## **Access Compliance Report Public Rights-of-Way** (Curb Ramps)

Intersection ID: N/A Main Street: TAMARACK DR **Cross Street: SINGLELEAF LN** Location: N **Overall Compliance: No Severity Score: ADA ID: 7BB1BDD61D81** Ramp Type: Perp Initial Pass/Fail: Fail 1.25

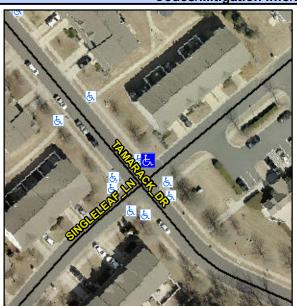
SINGLELEAF LN Street 1 Name Stop Condition-Street 2 StopSign Street 2 Name N/A Stop Condition-Street 1 N/A Possible Solutions: Remove & Replace Entire Ramp. Surveyor Notes: N/A PROW/ADA: Not Found, R304.5.3

Field Measurements/Component Compliance					
Compliance Description		Data	Comp	liance Description	Data
N/A	Ramp Length (in)	50.0	Yes	Ramp Slope (%)	7.0
Yes	Ramp Width (in)	48.0	No	Ramp XSlope (%)	2.8
N/A	Flare Type LT	N/A	N/A	Flare Type RT	N/A
N/A	Flare Slope LT (%)	N/A	N/A	Flare Slope RT (%)	N/A
N/A	Flare Traversable LT?	No	N/A	Flare Traversable RT?	No
N/A	Landing Length (in)	N/A	N/A	DWS Provided?	N/A
N/A	Landing Width (in)	N/A	N/A	DWS Contrast?	N/A
N/A	Landing Slope (%)	N/A	N/A	DWS Length (in)	N/A
N/A	Landing X Slope (%)	N/A	N/A	DWS Full Width?	N/A
N/A	Landing Curb? (Y/N)	N/A	N/A	DWS Offset (in)	N/A
N/A	Shared Landing?	N/A			
N/A	Gutter Ponding?	N/A	N/A	Gutter Slope (%)	N/A
N/A	Gutter Lip Ht (in)	N/A	N/A	Gutter X Slope (%)	N/A
N/A	Painted X Walk1?	No	N/A	Painted X Walk2?	N/A
	X Walk 1 Direction	To SE		X Walk 2 Direction	N/A
N/A	X Walk 1 Width (in)	N/A	N/A	X Walk 2 Width (in)	N/A
	X Walk 1 Slope (%)	3.1		X Walk 2 Slope (%)	N/A
